Figure 2.3.6-1

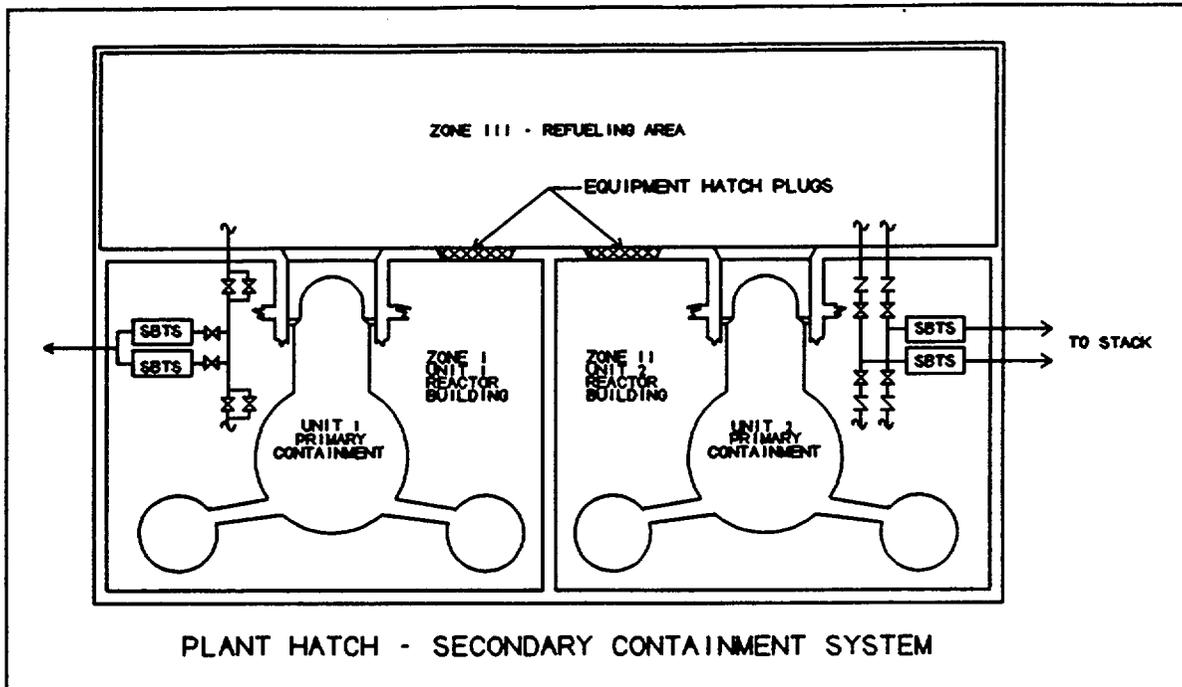
- Hatch Unit 1 "normal" secondary containment (Zones I and III);
- Hatch Unit 1 "modified" secondary containment (Zone III only); and
- Hatch Unit 1 and Hatch Unit 2 secondary containment (Here the Hatch Unit 1 secondary containment may be either "normal" or "modified"; i.e., either Zones I, II, and III, or Zones II and III are included).

These Zones are illustrated in Figure 2.3.6-1 below. The figure depicts the secondary containment and SGT configuration. It can be seen that each SGT subsystem is capable of drawing on any zone if penetration closure devices (e.g., hatch plugs, dampers, drain valves, doors) are properly positioned.

The improved TS for both units will simply refer to the requirement for secondary containment to be operable. "Secondary containment" is being defined in the Bases for improved TS 3.6.4.1 as those zone(s) that can be

postulated to contain fission products from accidents required to be considered for the condition of each unit, and furthermore, must contain zones not isolated from the SGT subsystems being credited for meeting improved TS 3.6.4.3, "SGT System." Allowed configurations and associated SGT subsystem requirements are being detailed outside the TS in the Technical Requirements Manual, which is referenced by the Bases. This safety evaluation describes these configurations and SGT subsystem requirements in Sections 2.3.6.2.r and 2.3.6.3.r. This change does not alter current secondary containment boundary requirements, but only the associated terminology. Thus, this change is purely administrative.
